Project	IEEE 802.16 Broadband Wireless Access Working Group < http://ieee802.org/16 >	
Title	Demodulation and Forwarding method in Relay Station	
Date Submitted	05-Mar-2007	
Source(s)	Su Chang Chae, Young-il Kim, Hyunjae Kim ETRI	schae@etri.re.kr
	Kyu Ha Lee, Changyun Kim, Yong Wook Lee Samsung Thales	kyuha.lee@samsung.com
	Chindapol Aik Siemens	Aik.Chindapol@siemens.com
Re:	Call for Technical Proposals regarding IEEE project P802.16j	
Abstract	Propose demodulation and forwarding method within a single frame in RS and change the technical tables.	
Purpose	Adoption of the proposed text and tables	
Notice	This document has been prepared to assist IEEE 802.16. It is offered as a basis for discussion and is not binding on the contributing individual(s) or organization(s). The material in this document is subject to change in form and content after further study. The contributor(s) reserve(s) the right to add, amend or withdraw material contained herein.

Demodulation and Forwarding Method in Relay Station

Figure3. Usage Scenario for Demodulation and Forwarding Method

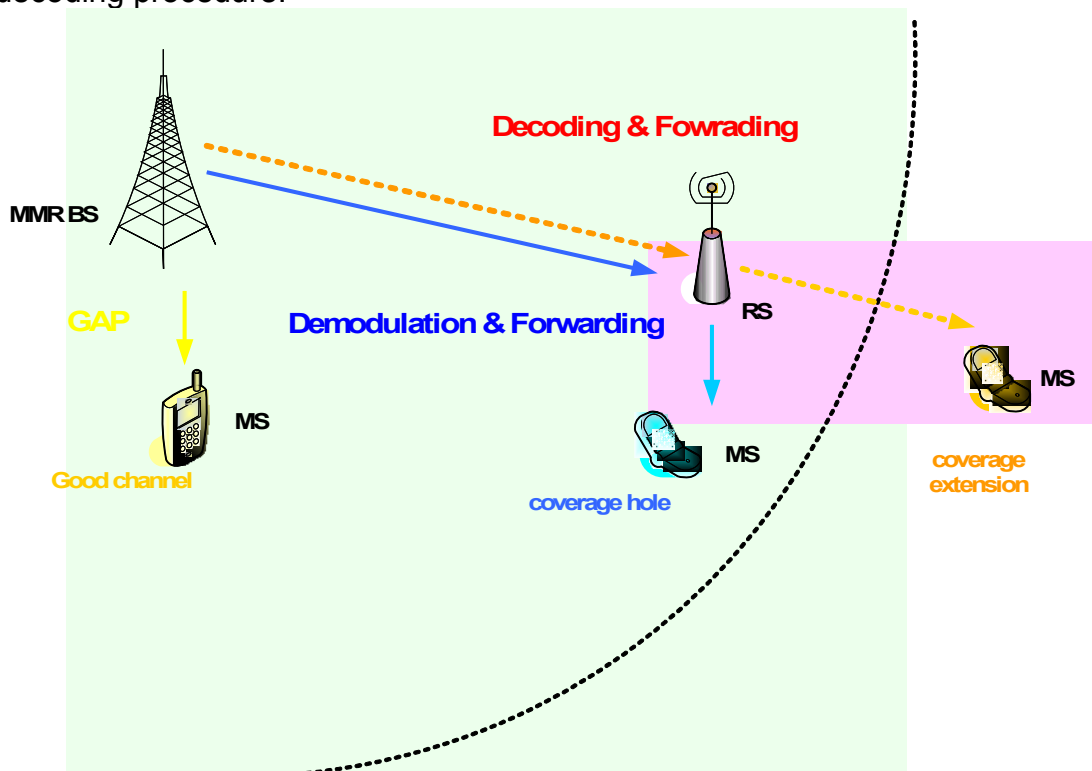
Figure3 shows you usage scenario considering MS's position.

There are three kinds of MS which are in the good channel, coverage hole and coverage extension area. MS in the good channel can be directly communicated with MMR-BS. MS in the coverage hole can be applied to demodulation and forwarding method in RS. And coverage extension can be applied to decoding and forwarding method in RS.

For example, in the case of using the demodulation and forwarding in RS for downlink, you can see that dark blue colored line indicates a BS-to-RS link and light blue colored line indicates a RS-to-MS link. It has not change code rate and encoding packet size, but modulation order of 64 QAM has changed by QPSK which can be forwarded to MS. Then, all of the MS should have channel decoding procedure.

Figure4. Burst allocation for Demodulation and Forwarding

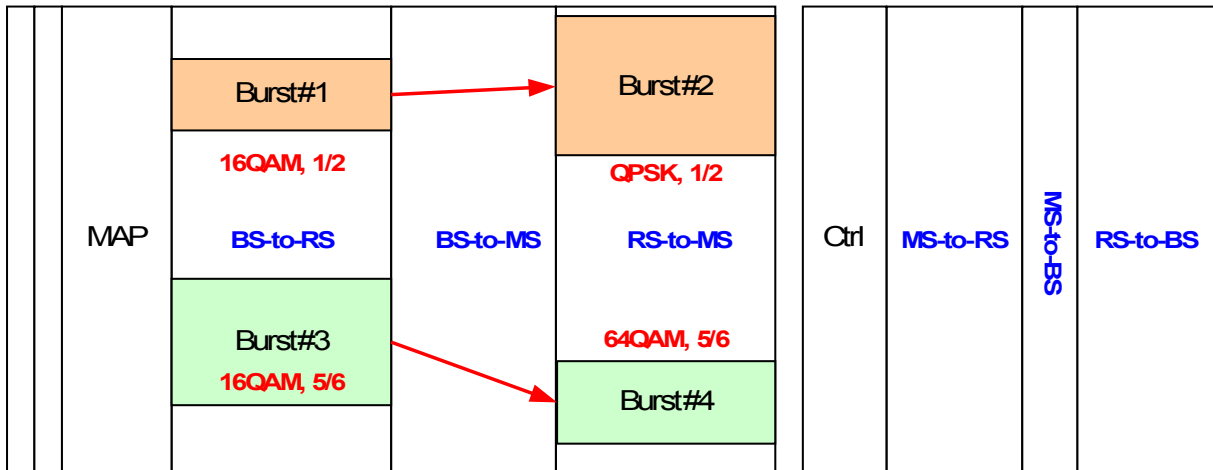
The figure4 depicts that burst#1 at the BS-to-RS region can be forwarded to burst#2 at the RS-to-MS region and burst#3 at the BS-to-RS region can be forwarded to burst#4 at the RS-to-MS region.

If burst#2's MCS should have QPSK, 1/2 code rate, burst#1's MCS may have 16QAM or 64QAM without changing of code rates. And also, if legacy MS should have MCS of 64QAM, 5/6 code rate at the RS-to-MS, burst#3's MCS may have 16QAM, 5/6. However, the legacy specifications of MS have not defined 5/6 code rate for 16QAM modulation type.

Finally, we may define all of the modulation types and channel coding rate for BS-to-RS to include a variety of modulation type and channel coding rates specifying for the legacy MS.
